Thank you for the opportunity to respond to the “RIIO-T1: Consultation on draft decision on National Grid Gas Transmission’s application under the RIIO-T1 Compressor Emissions uncertainty mechanism”. Our interpretation of Ofgem’s minded to position is in essence to delay making a decision until the 2018 reopener window. In this response by National Grid Gas Transmission (NGGT) we raise our concerns about this approach and provide further evidence to respond to the key points raised by the consultants.

Appendix 2: RB211 DLE Retrofit Emissions Assessment

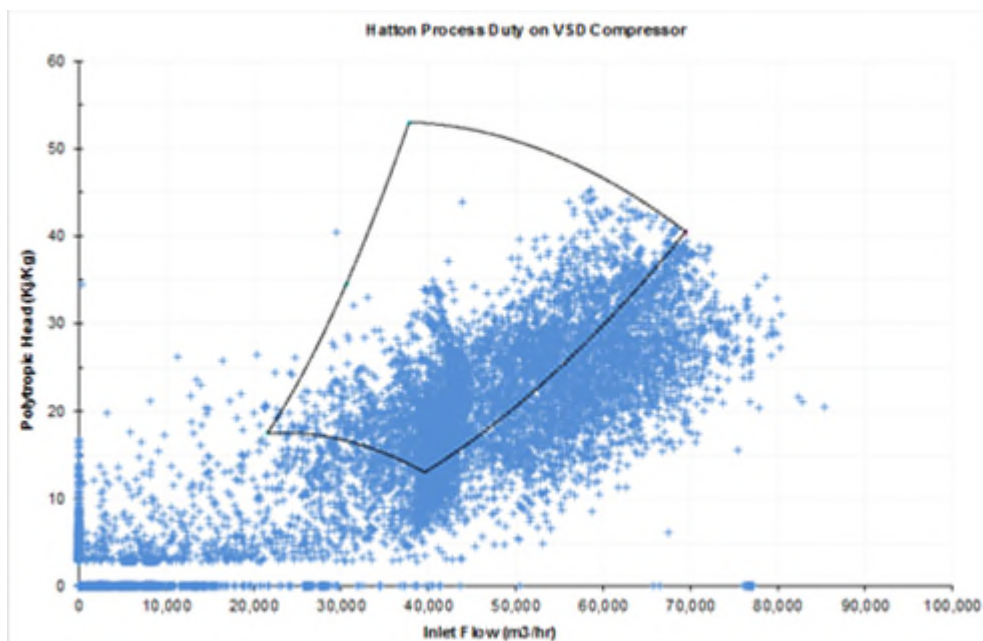
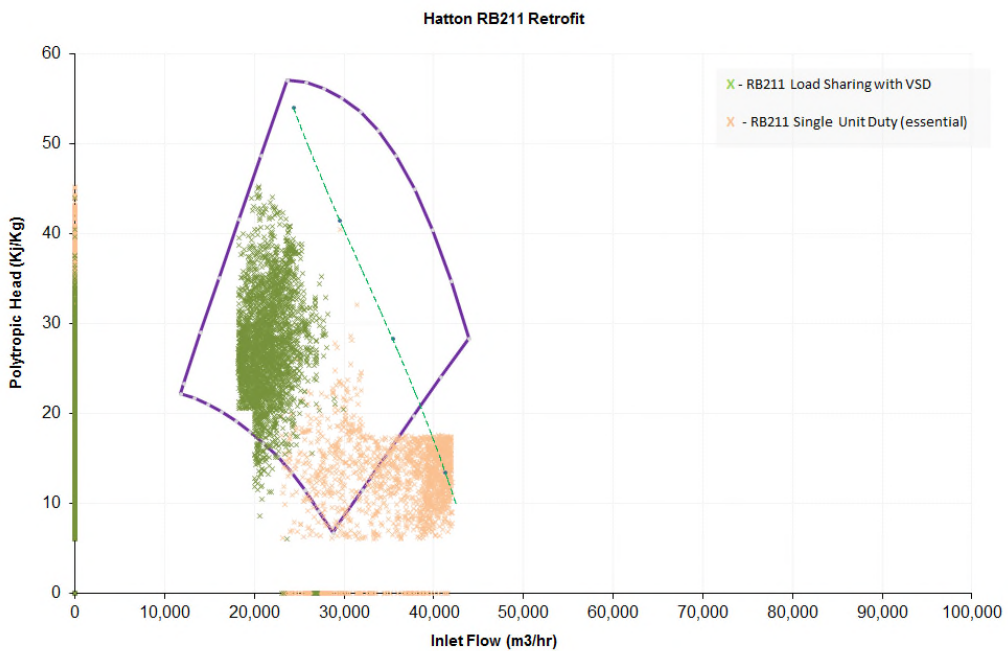
The option to retrofit is briefly discussed in the NGGT submission. NGGT refer to detailed studies which they made of compressor retrofit options, however these are not currently available for review. The BREF document [4] gives a number of retrofitting options which are considered BAT for reducing NOx emissions, but these are not mentioned here. These rely on reducing the overall combustion temperature inside the turbine. Broadly they can be categorised based on whether they are dry or wet.

Dry methods include DLE and DLN. DLE technology has been used to upgrade the existing engines at Aylesbury and so it is not clear why this is not considered elsewhere.

NGGT reject this option based on their stated findings that retrofit is only minimally less expensive than replacement. In fact retrofitting costs for DLN vary considerably between manufacturer and model, [4]. Therefore NGGT should have obtained retrofit quotes for the specific turbine makes and models involved in order to justify their conclusions. However, there is no mention of any such quotes obtained.

In terms of performance, the new retrofit RB211 DLE would need to operate in conjunction with Unit D, which is a 35 MW electric driven compressor. In Appendix 2, we show the typical duty points at Hatton and the points that would need to be covered by the RB211 DLE retrofit in either single or parallel operation with the larger unit D. The vast majority of the data points are below 70% load.

Below 70% the RB211 DLE retrofit is not able to meet the CO emission levels as specified in the IED. It would therefore not represent a BAT solution.

The operating points outside of the VSD envelope would need to be covered by another unit, i.e. the RB211 retrofit. Some of these points (green in the diagram below) would be covered by parallel operation and some of these points (orange in the diagram) below would be covered by single operation.

However, the RB211 DLE retrofit is only compliant with the CO emission limit specified in the IED at above 70% load and the diagram below shows the 70% load line. It can be seen that the vast majority of the data points fall outside of this range and therefore the RB211 retrofit is not considered BAT for Hatton.
